ESQUIRE SWEATERS LTD. (EXTENSION)

16 February 2025

1. Building Information

Observation-01: Lack of lateral stability system (load transfer media, vertical bracing) (Dining and Yarn Store Shed)

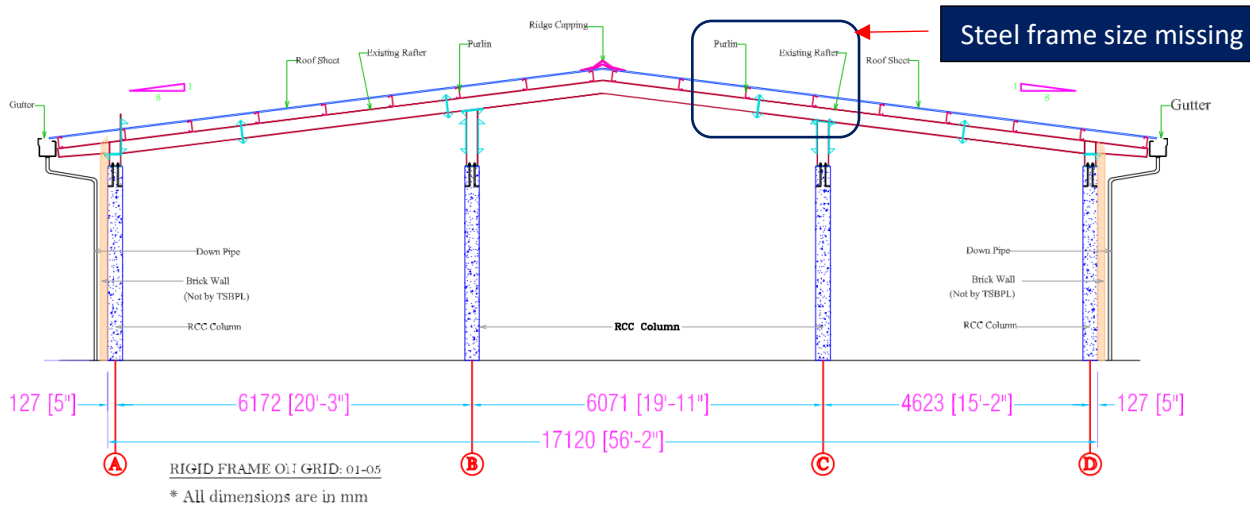
Lack of stability system

Description: Portal frames were observed along the short direction of the sheds, Along the long direction of the sheds, lateral stability systems (load transfer media/ compression strut, vertical & horizontal bracing) were not observed.

Building engineer is required to carry out an Engineering Assessment (EA) of the shed to check the lateral stability of the shed and suggest necessary remedial action.

Observation-03: Improper connection and connection gap (Dining and Yarn Store Shed)

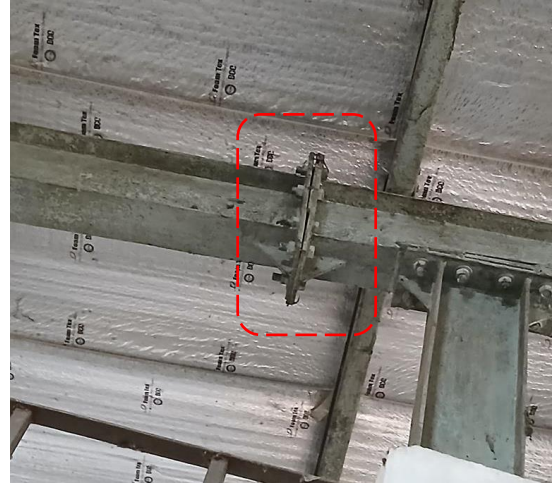
Improper connection and connection gap

Description: Improper connections and connection gaps were found in the dining and yarn store areas. The building engineer is required to repair the gaps with a suitable method and ensure adequate strengthening where necessary.

Observation-06: Lack of truss/member adequacy and poor connection. (Wastage store)

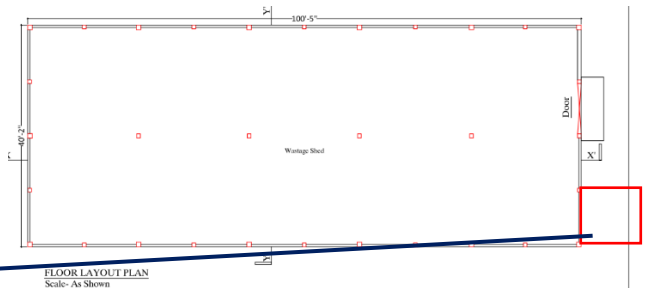
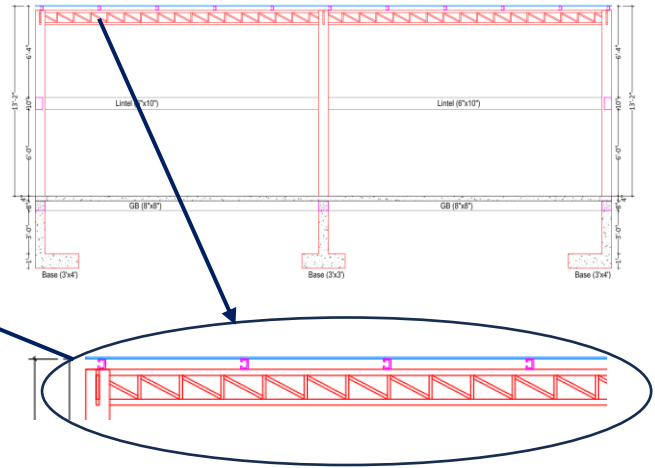
Stability System

Description: The span/depth ratio of the truss is smaller, which indicates the truss appeared to be inadequate. Also, the connections were appeared to be improper. The building engineer is required to check the adequacy for the truss & connections as part of EA report and suggested proper remedial actions accordingly.

Observation-09: Lack of as-built drawings (Security Dormitory Building)

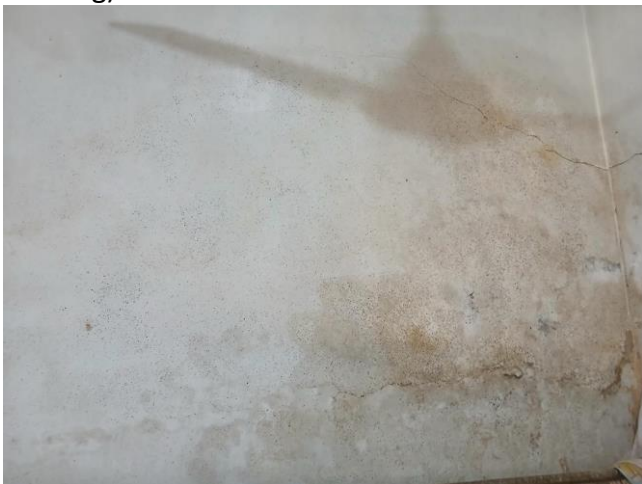
Description: As-built drawings were not available on site.

The building engineer is required to survey the structures and prepare as-built drawings for the structures with foundation details.

Observation-12: Lack of as-built drawings (Fire Pump & Water Reservoir)

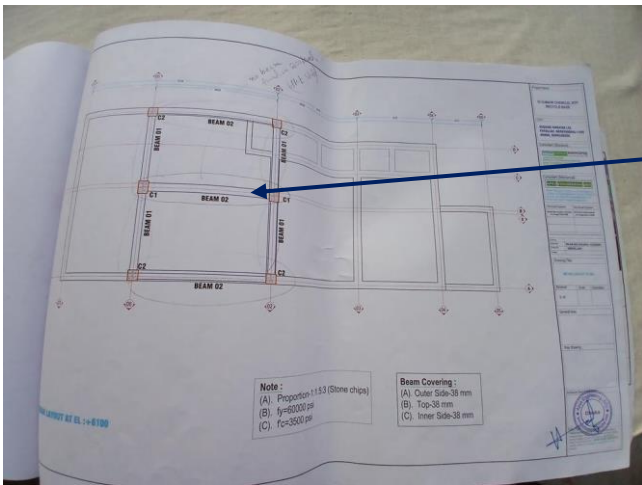
Description: As-built drawings were not available on site.

The building engineer is required to survey the structures and prepare as-built drawings for the structures with foundation and necessary connection details.
